**RE: Headline Blvd (Legacy at Journal Center)
 Grading Plan
 Engineer's Stamp Date 2/21/2017
 Hydrology File: D17D106**

Based upon the information provided in the submittal received on 2/21/2017 the above-referenced Grading Plan is not approved for Grading, SO-19, or Paving Permit. The below items must be addressed prior to approval.

GRADING AND DRAINAGE PLAN

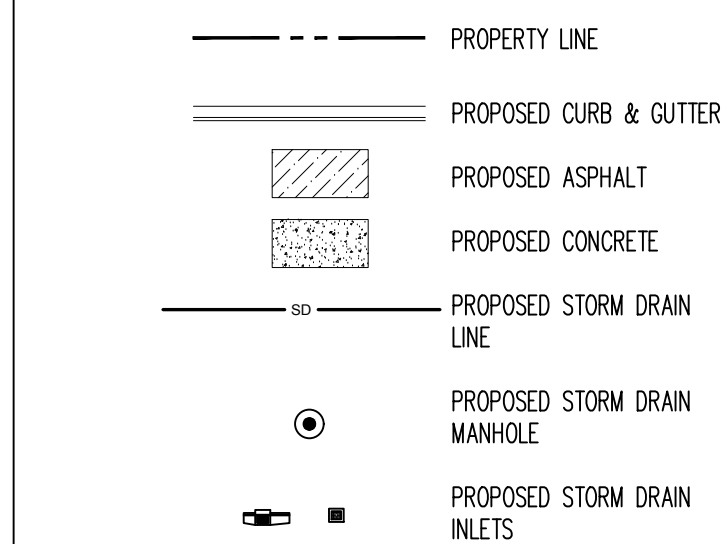
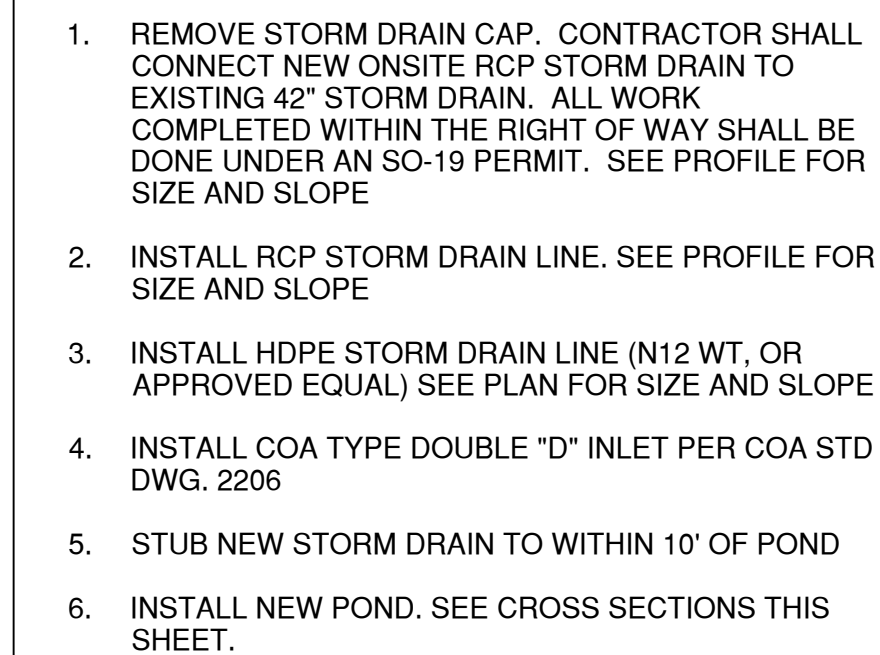
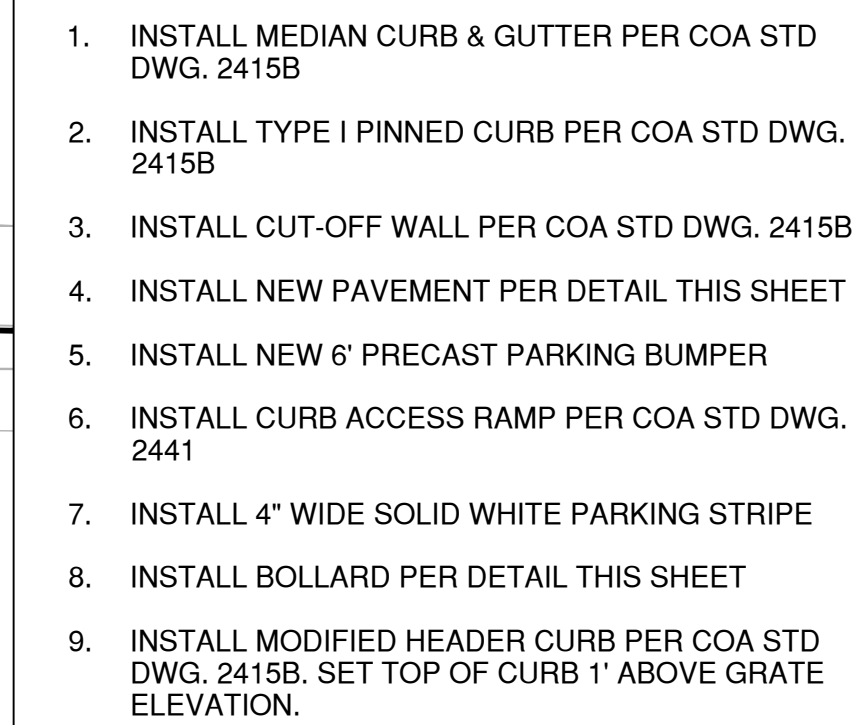
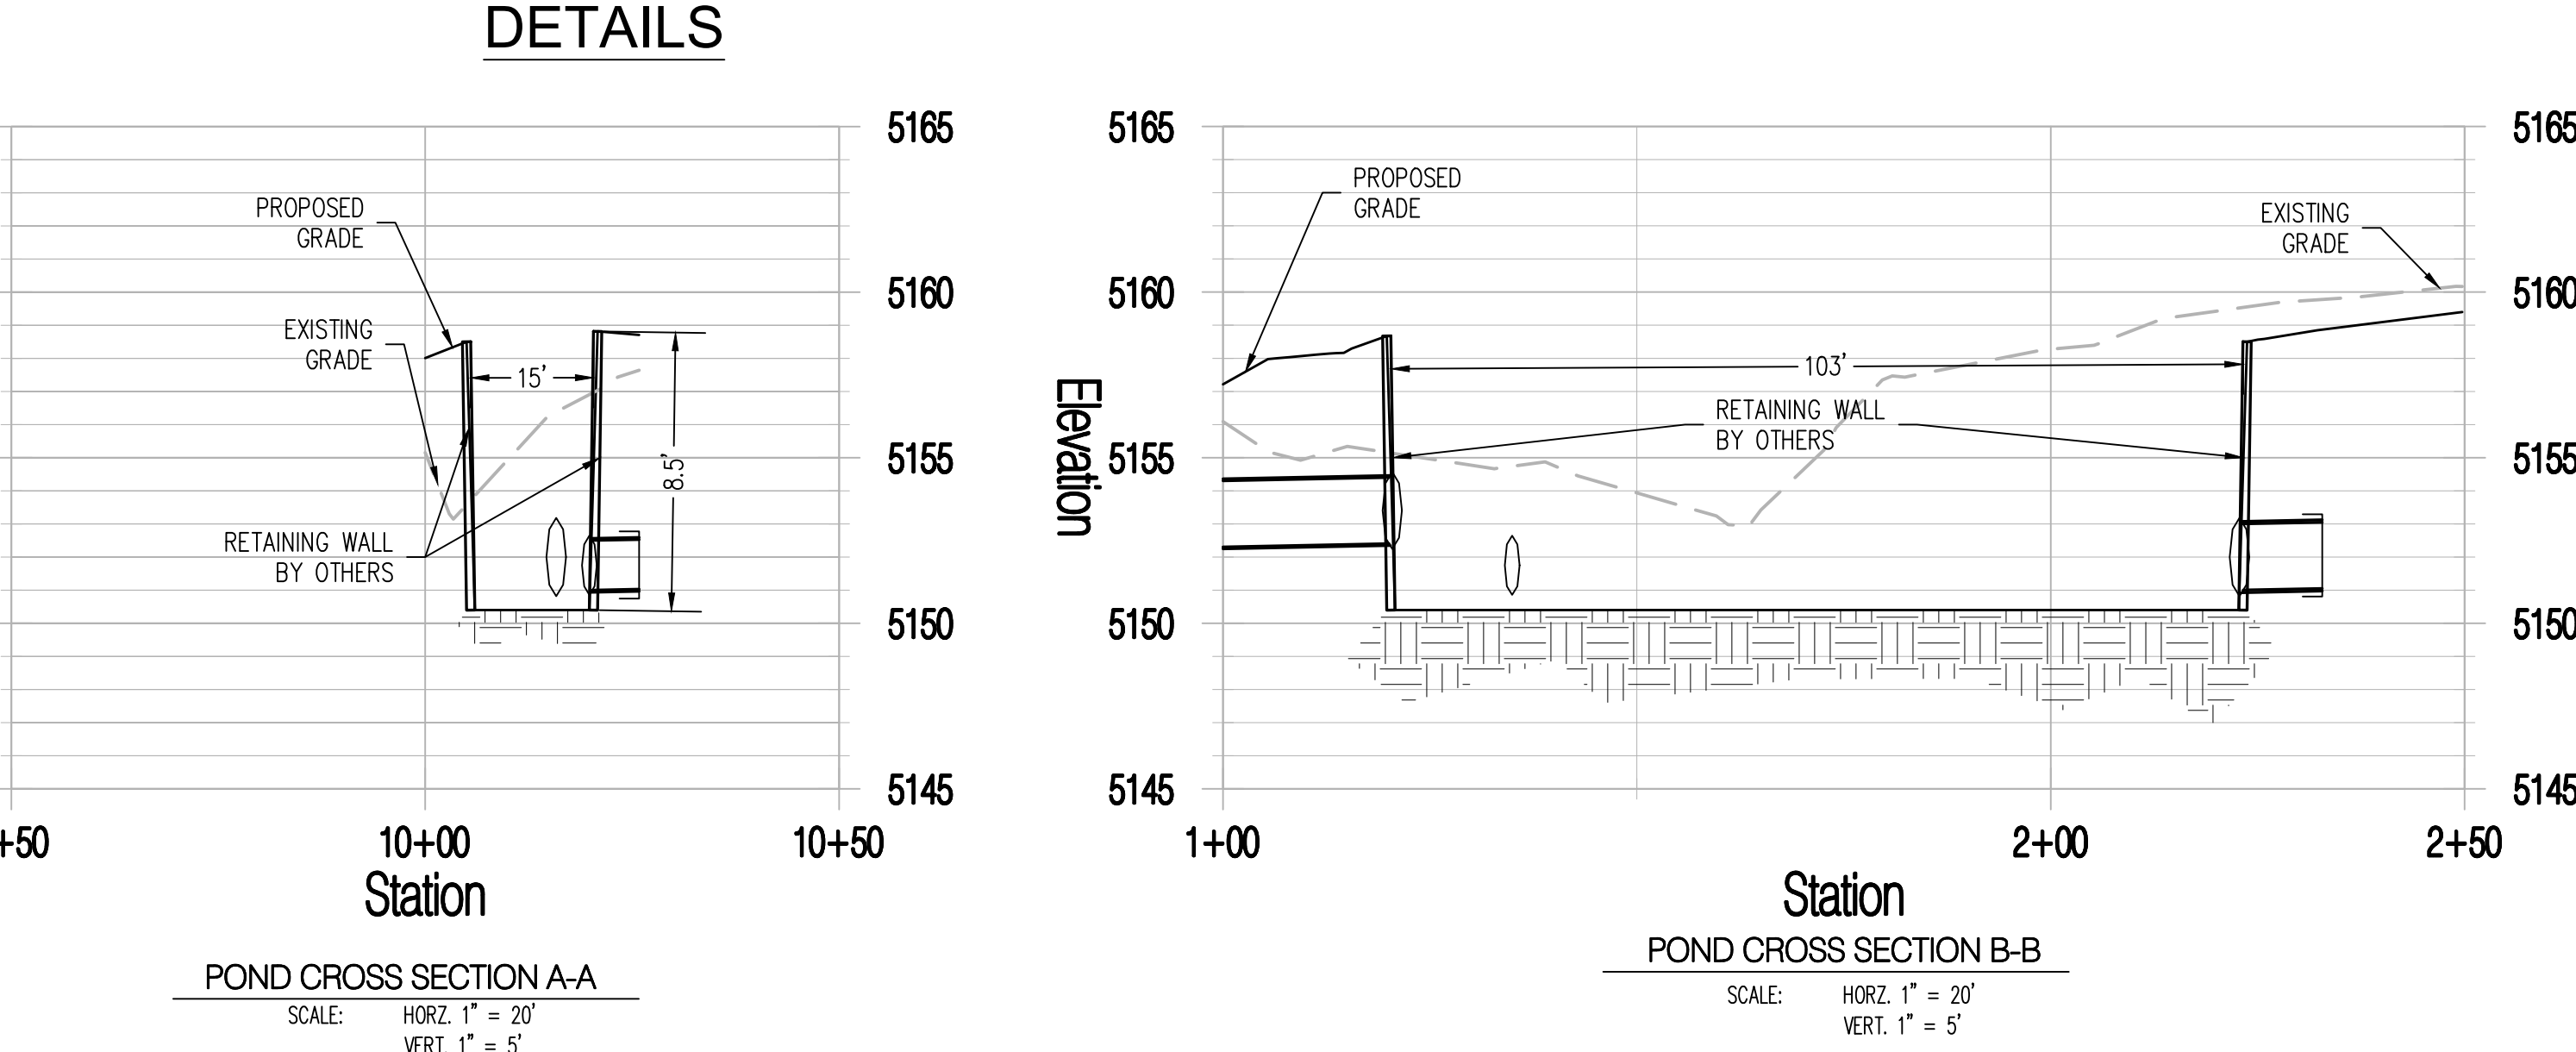
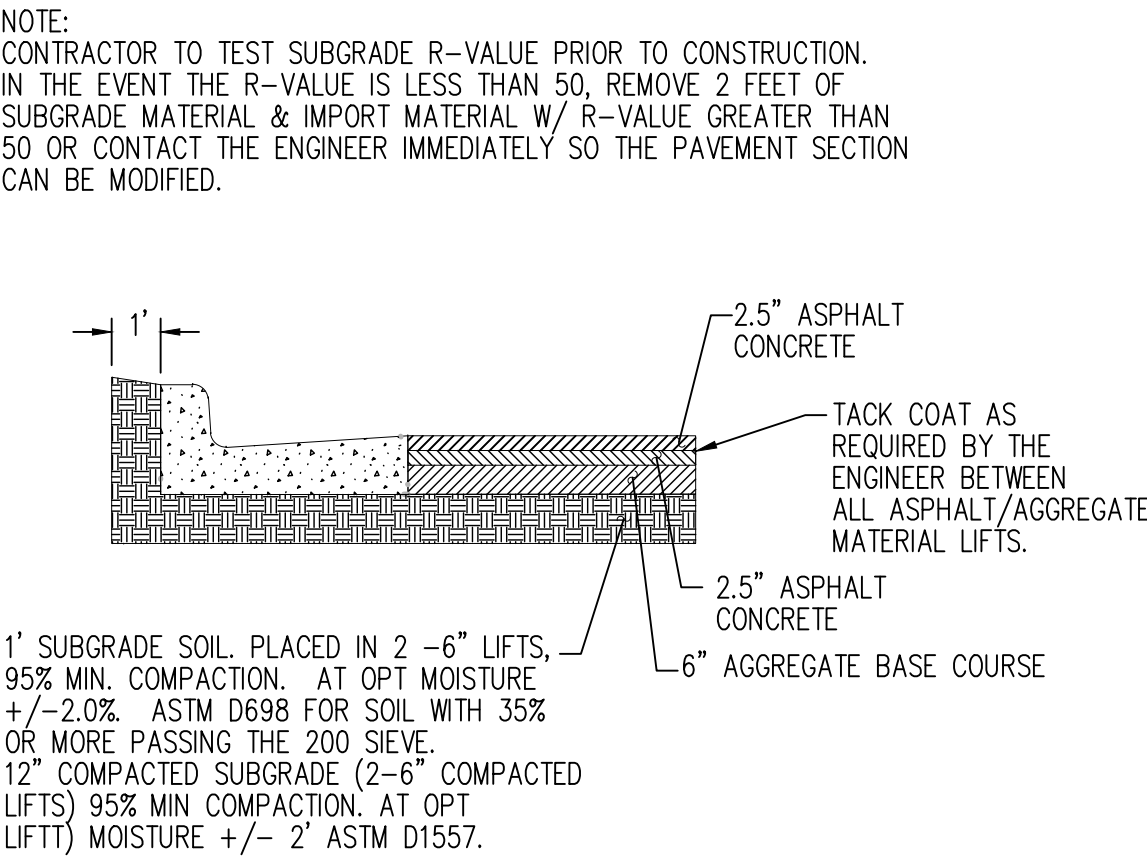
1. Inlet structure and connection to the 42" storm drain.
 - a. The existing 42" storm drain is HDPE, show how the connection will be made to the new 8.51' section of 42" RCP storm drain.

- b. The type double-D inlet will need to be rotated 90 degrees as the width is only 2' 1 1/2" wide and won't connect to the 42" storm drain. A larger junction box is likely needed here as explained below.

- c. Determine the grate capacity, and head required to allow 46 cfs into the type double-D inlet structure with 15% clogging. The sump around the inlet will need to contain this plus freeboard. A larger junction is likely needed here to provide more capacity.

2. Drainage along former Headline.
 - a. Provide a section cut of the new Headline Blvd parking area, showing flow depths through this area. The cross-slope pushing all flows to the west side does not appear adequate for conveying 46 cfs. An inverse crown with valley gutter (alley) may be more effective here; this would also keep flows from being obstructed by the parking islands.

- b. Provide elevations along the western edge of the property; a waterblock may be needed to keep flows from entering the property to the west.

3. Pond.
 - a. The proposed pond includes 8.5' vertical walls all around. Provide a fence or barricade around the pond at least 42" high and provide emergency access into and out of the pond.
 - b. The pond needs to be sized to retain the first flush volume for basin B2-A. If other storm water quality facilities are proposed for treating Basin B2-A water, include those in the Grading and Drainage Plan.
 - c. Add water surface elevations for the first flush elevation and the 100-yr, 6hr elevation.
4. General.
 - a. The curb access ramp for the bike path needs to be as wide as the bike path.
 - b. The finished floor of the 9,000SF retail space is below the proposed grade. Should this be raised?
 - c. Add areas (square-footage) for area of grading and area of new paving.
 - d. Call out work items to be performed by SO-19.
